## INDEX

### DEFINITIONS

9202250217 920214  
PDR ADDCK 05000528  
P PDR

FIGURE 5.1-1

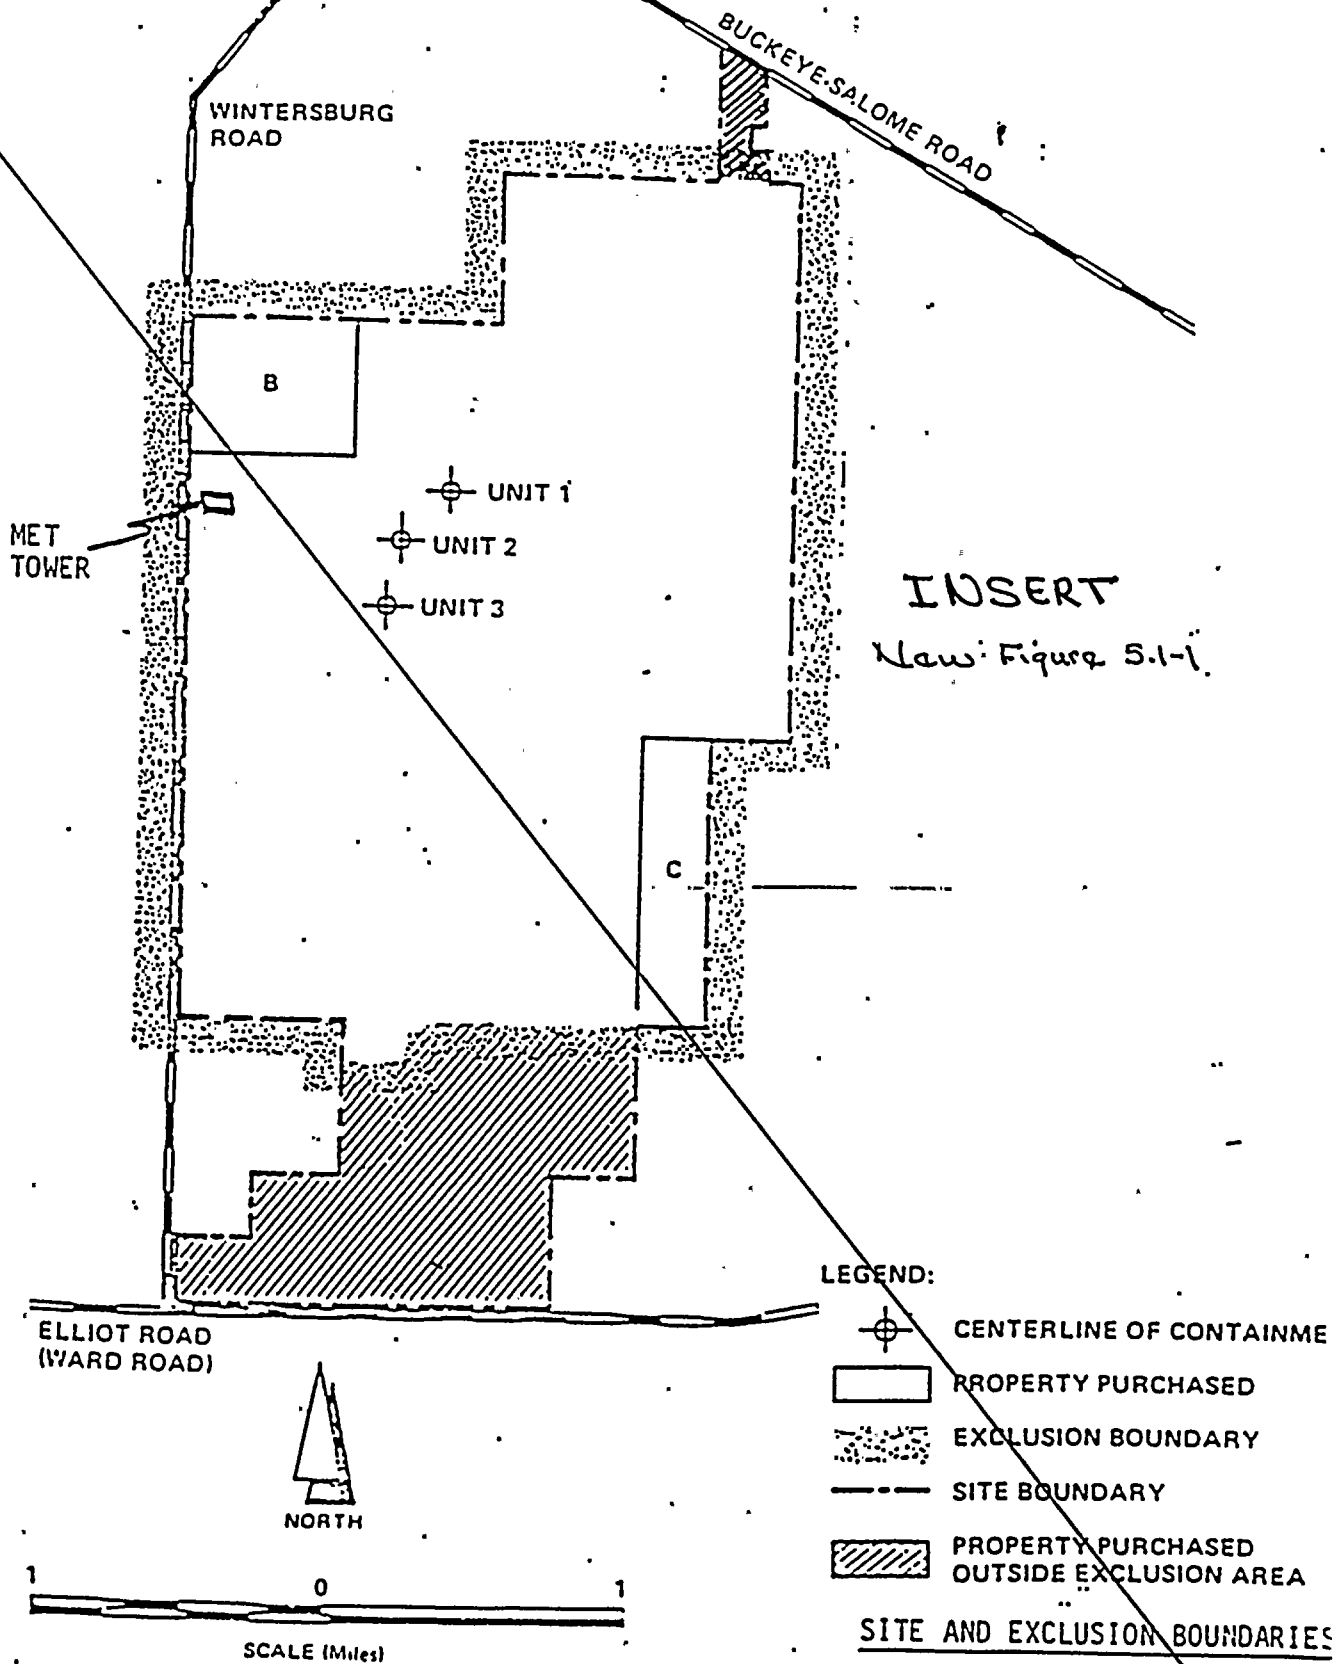
INSERT  
New Figure 5.1-1

FIGURE 5.1-2

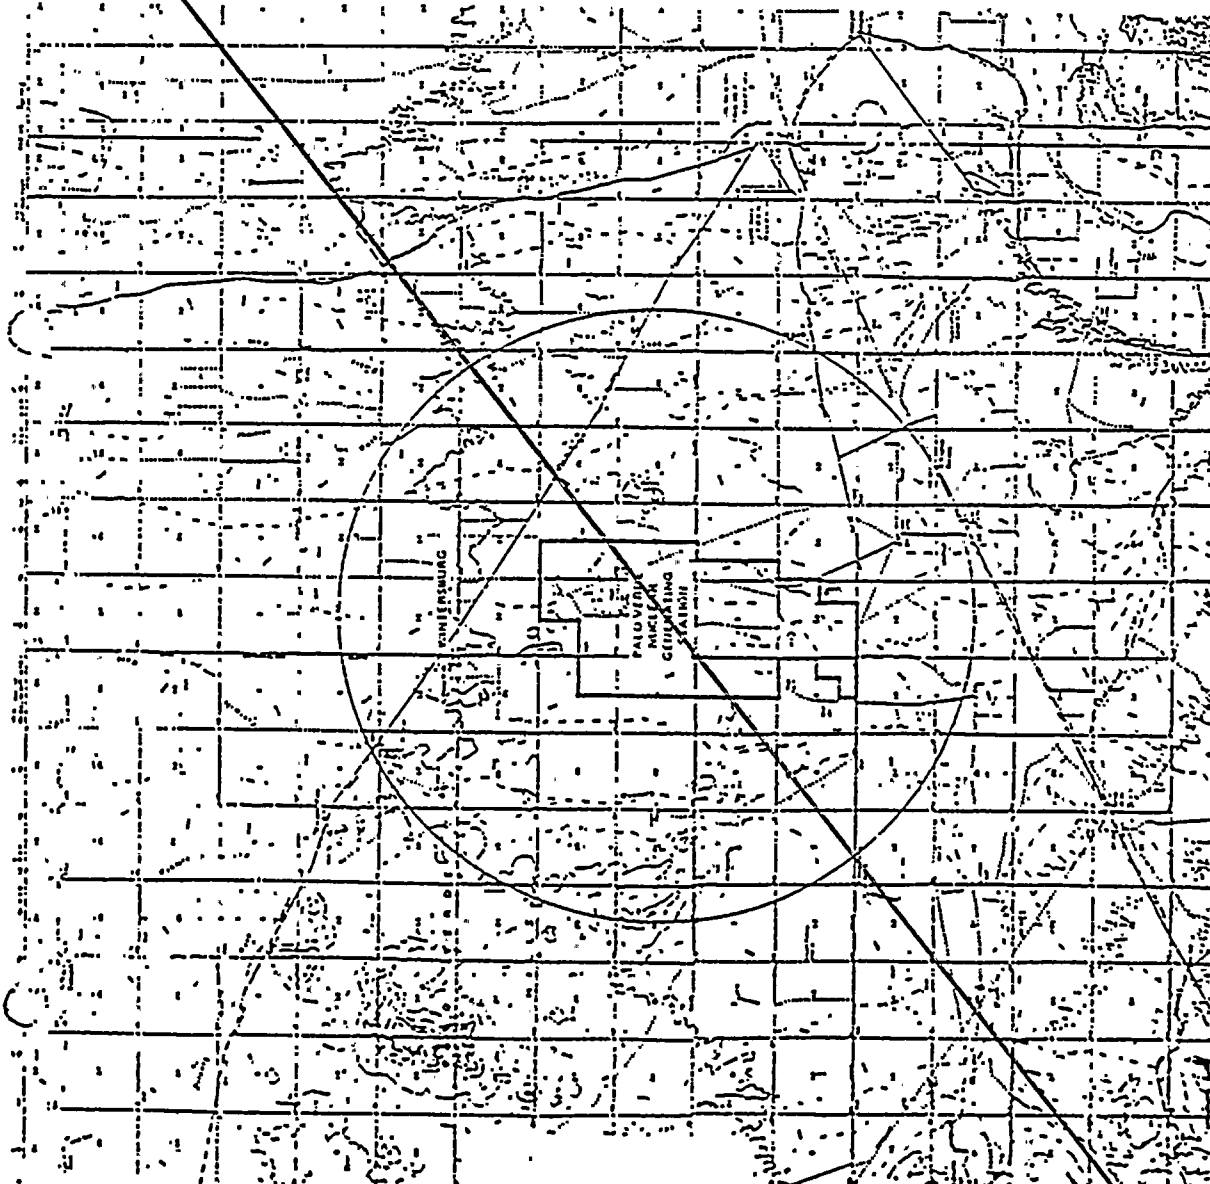
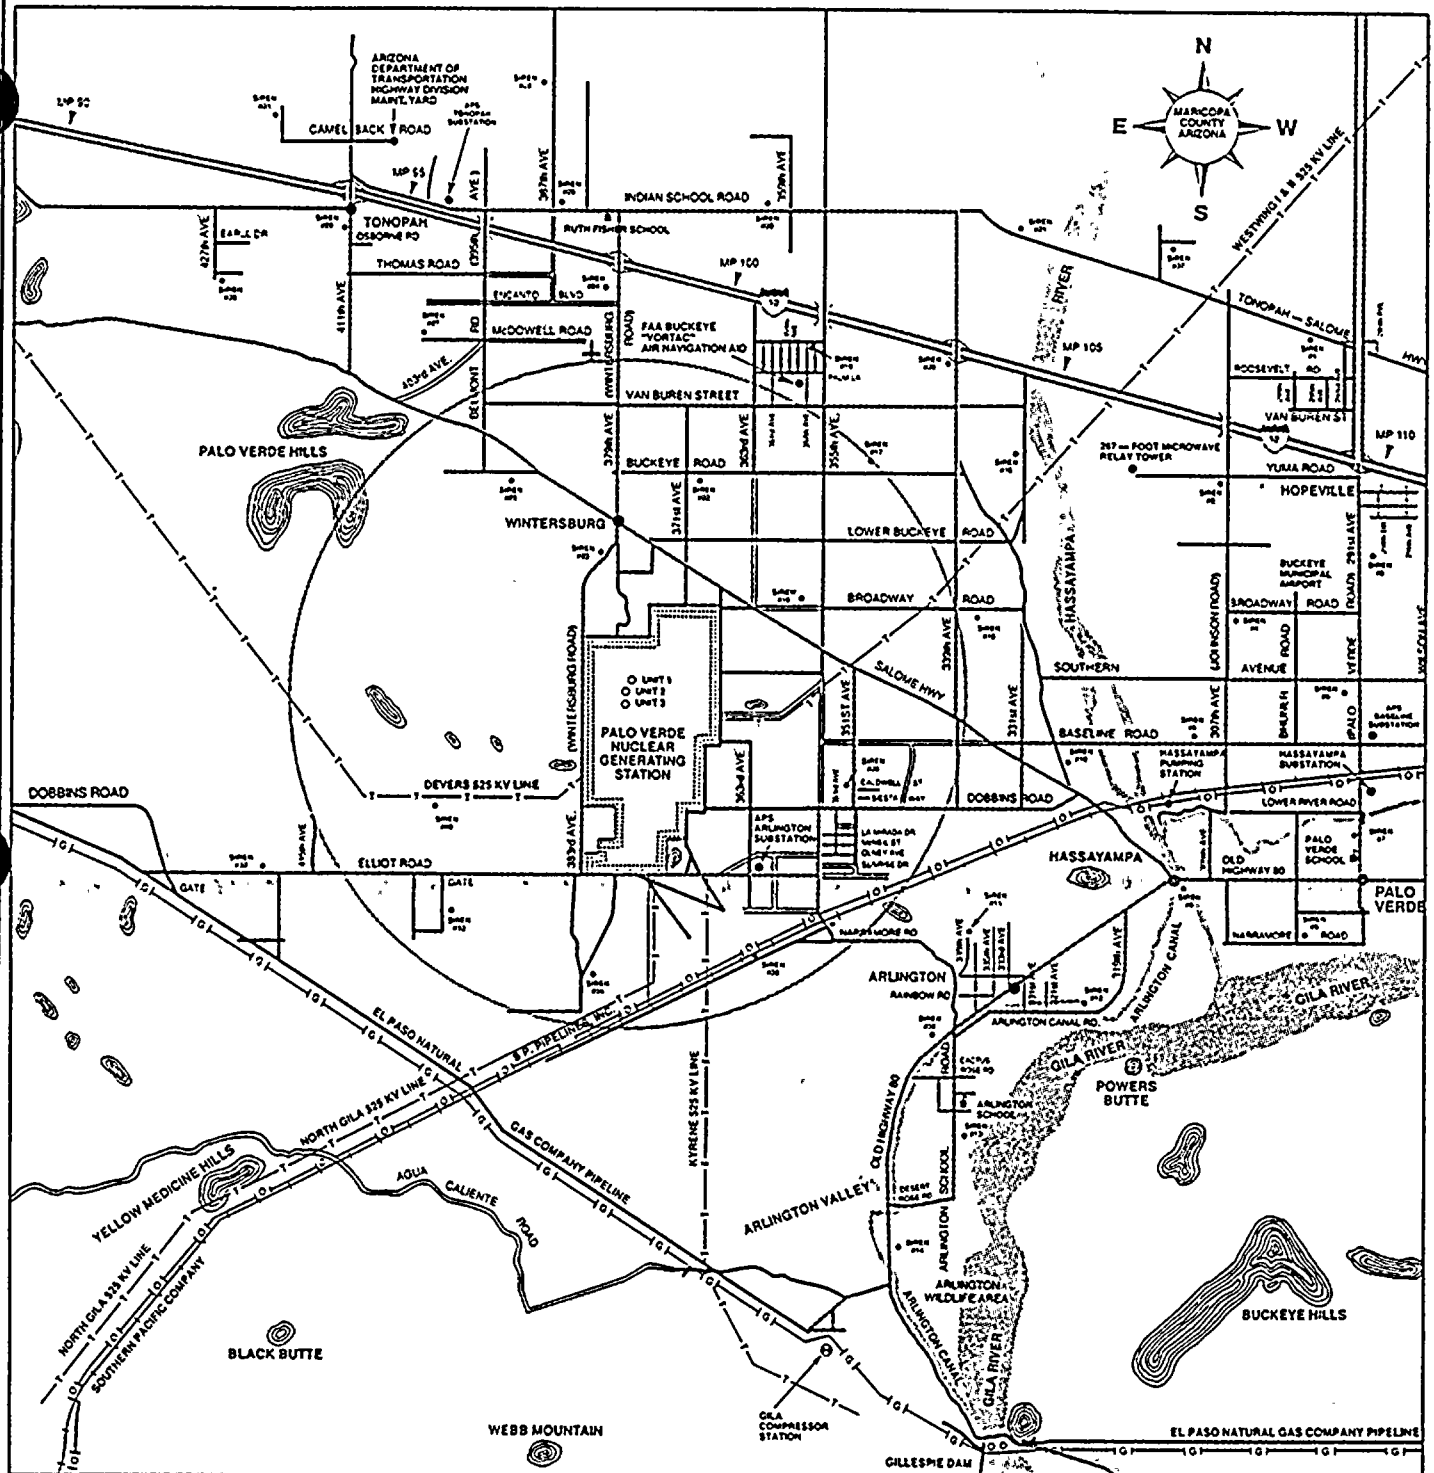
INSERT New Figure 5.1-2

FIGURE 5.1-3

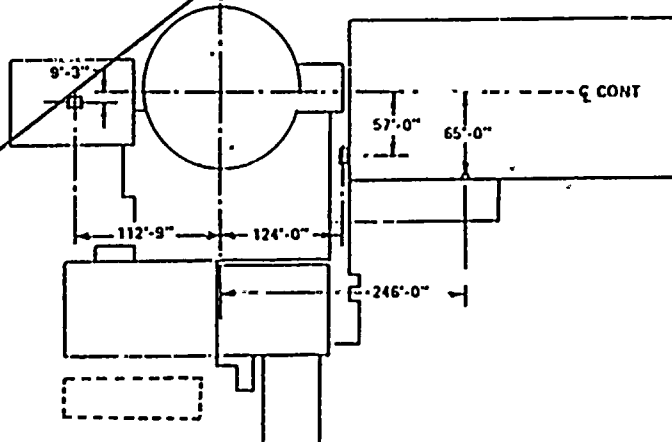
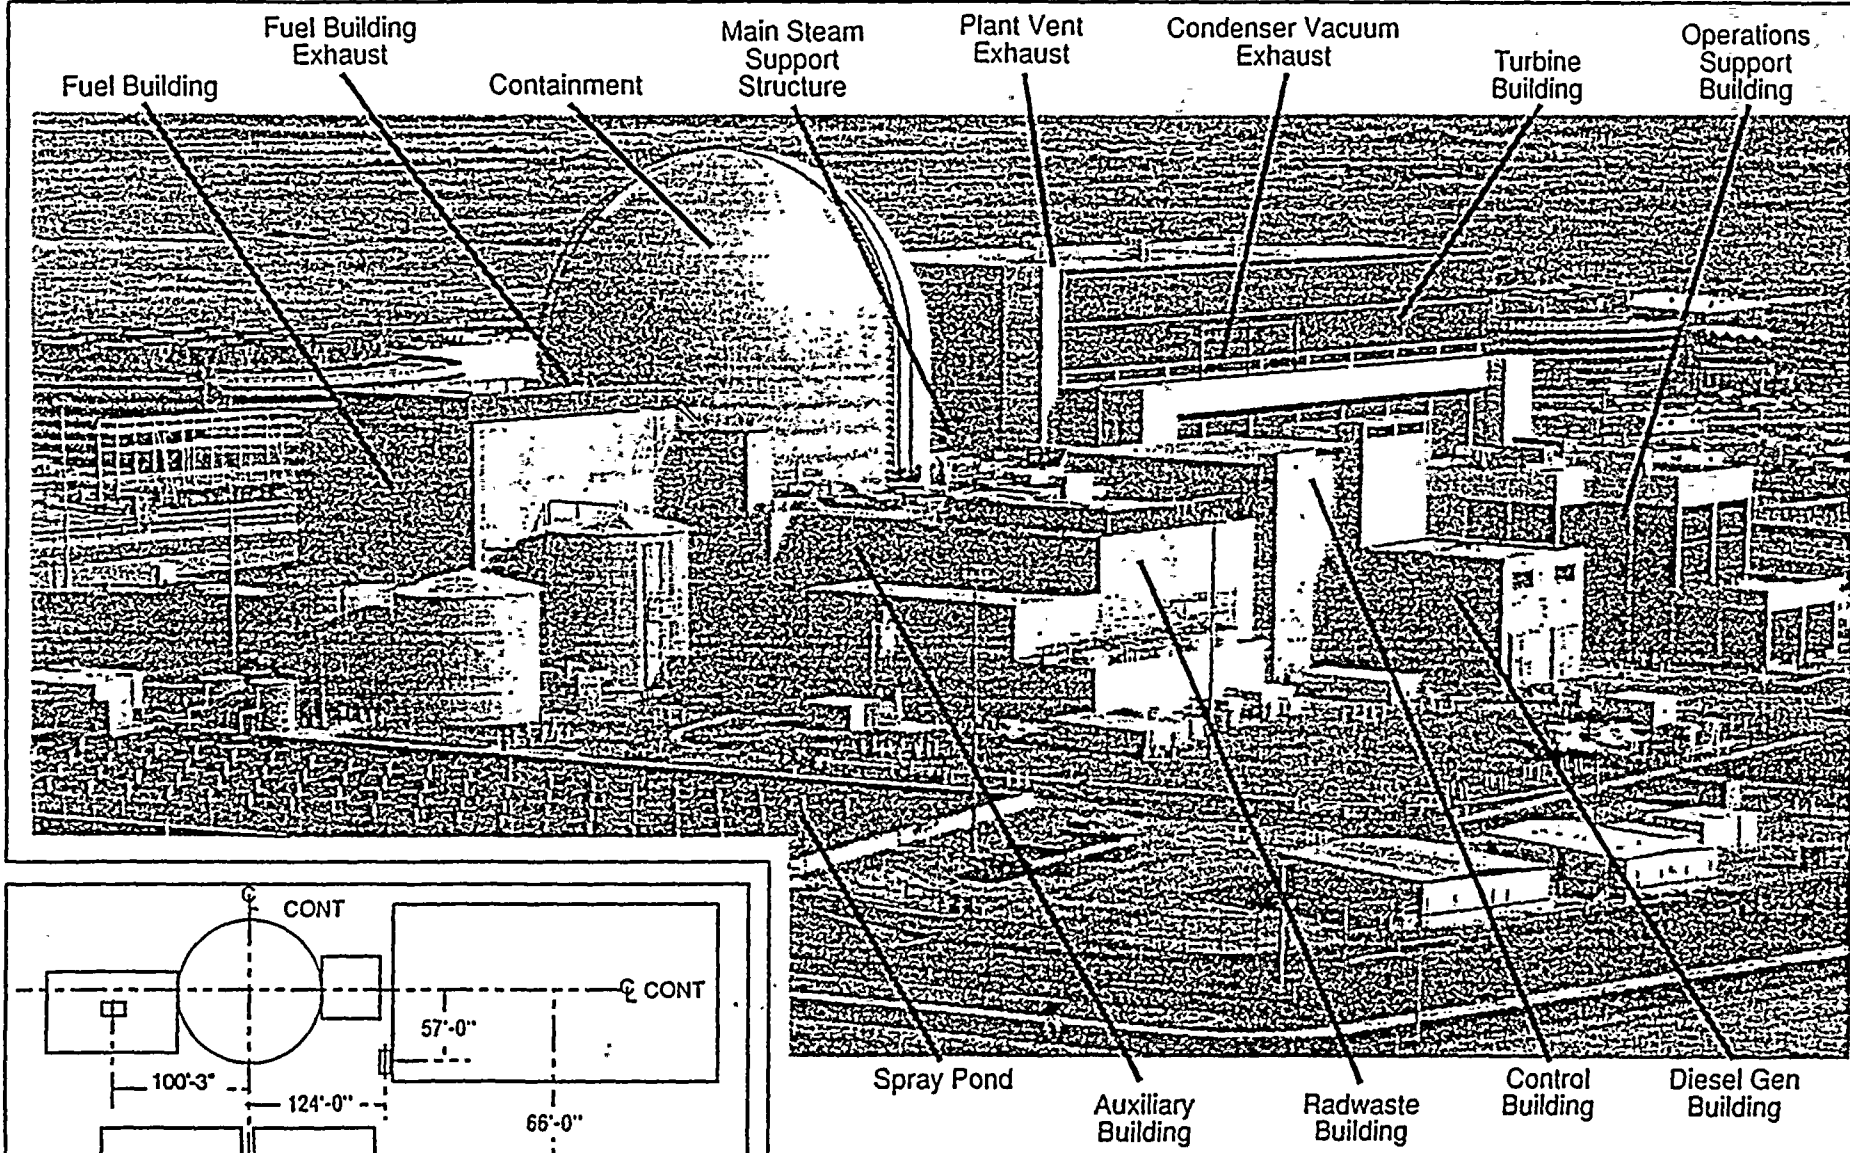
INSERT  
New Figure 5.1-3
